DRB 2015-SA-76-037B

Repair Doubler on RHS Center Firewall

SIKORSKY AIRCRAFT DESIGN RECORD BOOK

Figure 2: No. 2 Engine Bay Firewall Crack at Y-Pipe Pass-Through

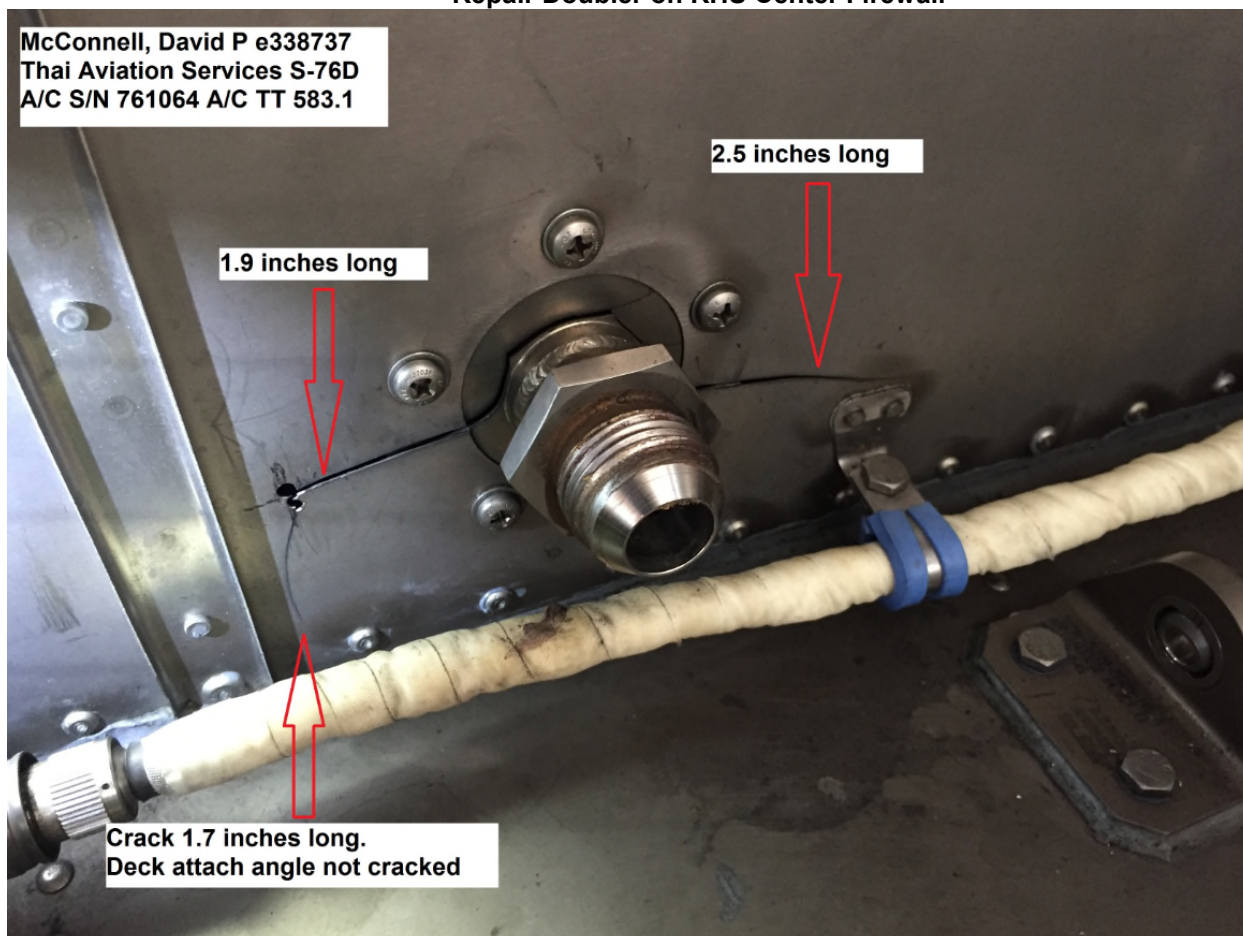
During performance of the first 600-hour inspection and removal of the Y-pipe installation per AMM Subtask 21-40-00-610-002 on A/C S/N 761064 TAS maintainers noted cracking of the P/N 76202-77002-046 No. 2 engine bay firewall at the Y-pipe pass-through.

Three cracks were noted in the firewall. All are in excess of cracking illustrated in DRB 2015-SA-76-037A.

- One horizontal crack 2.5 inches long emanating from the pass-through opening at approximately the 4 o'clock position, running forward.
- One horizontal crack approximately 1.9 inches long emanating from the pass-through opening at approximately the 9 o'clock position, running aft, terminating approximately 0.030 inches from the forward edge of the vertical stiffener.
- One vertical crack approximately 1.7 inches high, approximately 0.5 inches forward of the vertical stiffener at its closest point. This crack intersects the aft horizontal crack. There are no pieces missing. The firewall deck attach angle was inspected for cracks. None were found.

Figure 4: Doubler Installed Over RHS Y-Tube Pass Through

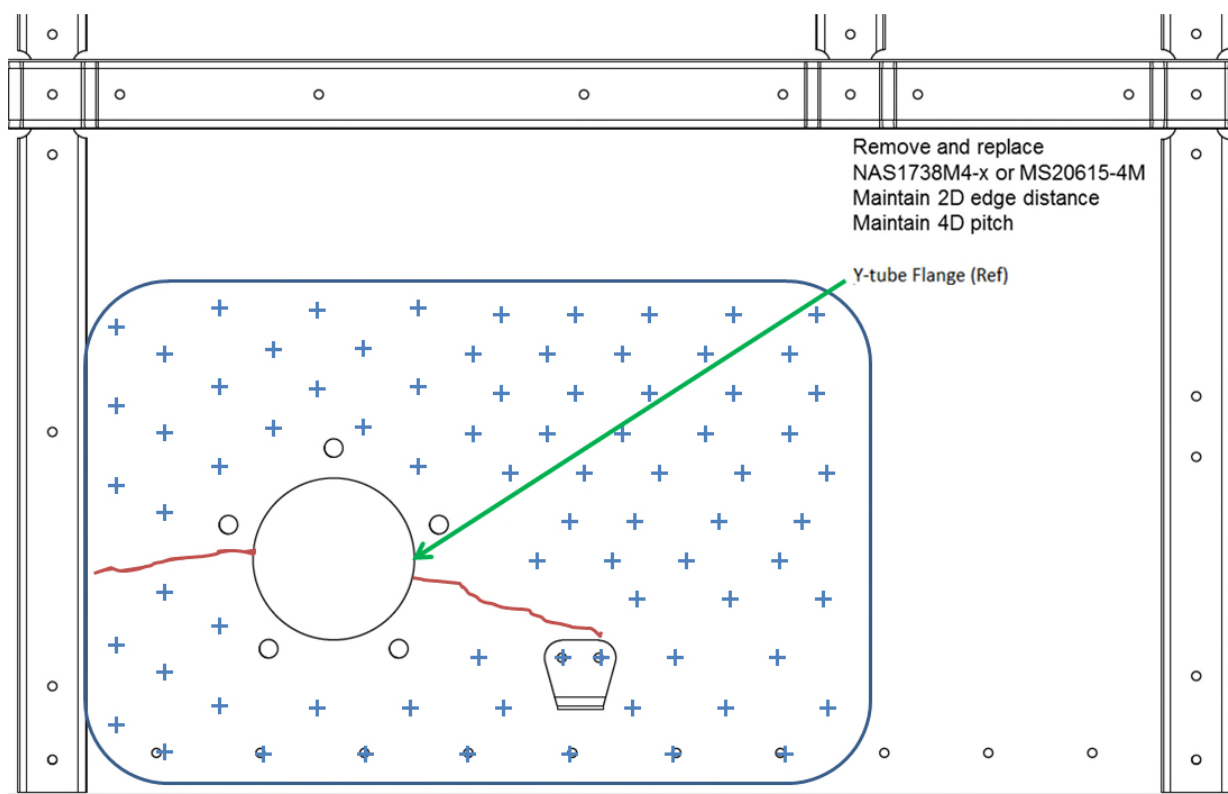
1) Please confirm that the repair procedures called out in DRB 2015-SA-76-037A are applicable to address the cracking as noted above, with adjustments to standard practices in order to accommodate a larger repair doubler. TAS have 0.020, 0.025 and 0.030 301 ¼ Hard SS available. They do not have any Ti sheet stock on site.

10. Fabricate a reinforcement doubler from cracked access panel approximately as shown in Figure 4. Reorient as necessary to avoid crack and existing fastener holes. The doubler will be made of 0.020 TI 6AL-4V, or 0.025 301 $\frac{1}{4}$ HD SS as available. The doubler will be centered on the Y-tube pass through hole on the outboard side of the RHS firewall, extended in one direction to vertical member and in the other direction past the attach clip for the hose as shown in Figure 4. The doubler shall be sized to allow a staggered row of 1/8" fasteners, maintaining 2D edge distance and a minimum of 4D pitch on the fasteners. Corner radii shall be 0.190" minimum. Deburr the edges of the doubler. Avoid Crack and existing fastener holes.

11. Temporarily locate the doubler in place. Back drill any removed fastener locations that would be common to the doubler. Transfer pass through hole and flange mounting holes to doubler using Plexiglas to trace the location of the holes as necessary from firewall as shown in Figure 4.

12. Remove the doubler and pilot drill fastener holes. Form two rows maintaining 2D edge distance and a minimum of 4D pitch on the fasteners. Again temporarily locate the doubler in place and use the pilot holes to mark the fastener locations on the original skin panel.
